# Service Bulletin

**Bulletin No:** 2009-1-08

**Subject:** Oil Pump Union Bolt

**Affected Models:** All 2009 F8 models

Fig. 2

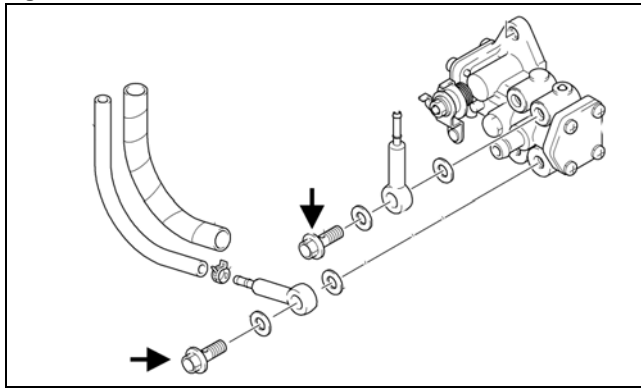
**Condition:** It has been determined that the oil pump union bolts are not tightened to Arctic Cat standards which will result in oil leakage and eventually engine failure.

7. Tighten top and bottom oil pump union bolts securely. (6 ft-lb) See Fig. 2.

**Solution:** Tighten top and bottom oil pump union bolts. (6 ft-lb) See Instructions in this service bulletin.
